Economic Commission for Europe**Inland Transport Committee****World Forum for Harmonization of Vehicle Regulations****172nd session**

**1958 Agreement: Consideration of draft amendments
to existing Regulations submitted by GRSP****Proposal for Supplement 1 to the 02 series of amendments to
Regulation No. 129 (Enhanced Child Restraint Systems)****Submitted by the Working Party on Passive Safety***

Supplement 12 to the 02 series of amendments to Regulation No. 129 (Enhanced Child Restraint Systems)

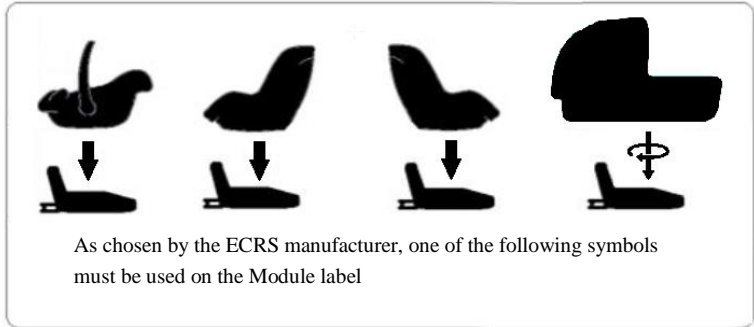
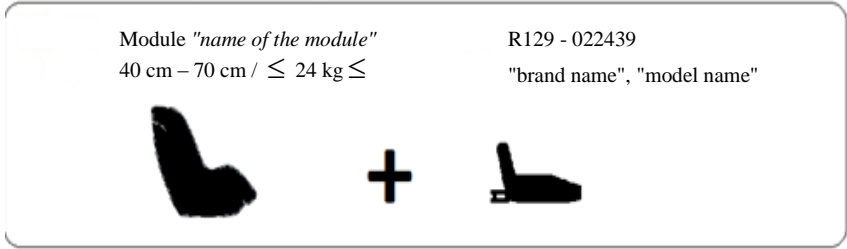
Annex 2, Arrangements of the module mark in combination with an approval mark, the figures, to be deleted and insert new figures, to read:

Figure 1

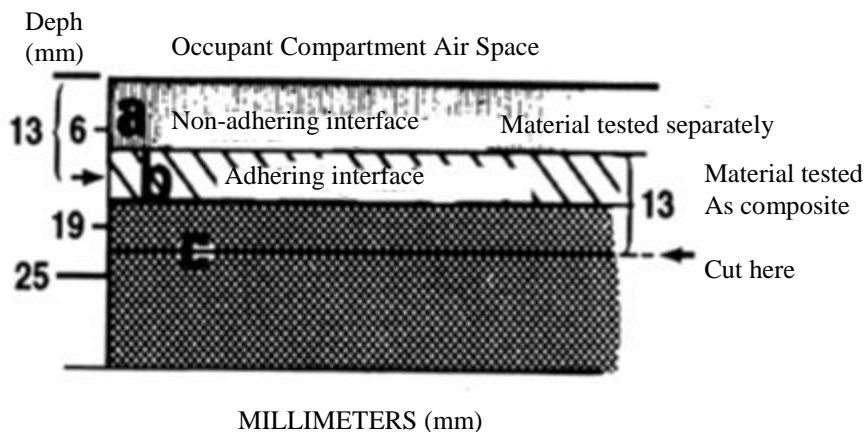
2. Material selection (see Figure 1 below)

2.1. Any portion of a single or composite material which is within 13 mm of the occupant compartment air space shall meet the requirements in Paragraph 6.1.6.

Material A has a non-adhering interface with material B and is tested separately.

Part of material B is within 13 mm of the occupant compartment air space, and materials B and C adhere at every point of contact; therefore, B and C are tested as a composite.

The cut is in material C as shown in Figure 1, to make a specimen 13 mm thick.

Figure 2
All dimensions in millimeters (mm)

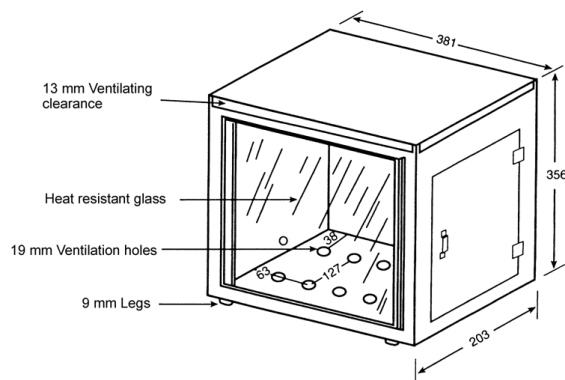
3. Test procedure
 - 3.1. The test is conducted in a metal cabinet for protecting the test specimens from drafts. The interior of the cabinet is 381 mm long, 203 mm deep, and 356 mm high. It has a glass observation window in the front, a closable opening to permit insertion of the specimen holder, and a hole to accommodate tubing for a gas burner. For ventilation, it has a 13 mm clearance space around the top of the cabinet, ten holes in the base of the cabinet, each hole 19 mm in diameter and legs to elevate the bottom of the cabinet by 10 mm, all located as shown in Figure 2.
 - 3.2. Prior to testing, each specimen is conditioned for 24 hours at a temperature of 21° C, and a relative humidity of 50 per cent, and the test is conducted under those ambient conditions.
 - 3.3. The test specimen is inserted between two matching U-shaped frames of metal stock 25 mm wide and 10 mm high.

The interior dimensions of the U-shaped frames are 51 mm wide by 330 mm long.
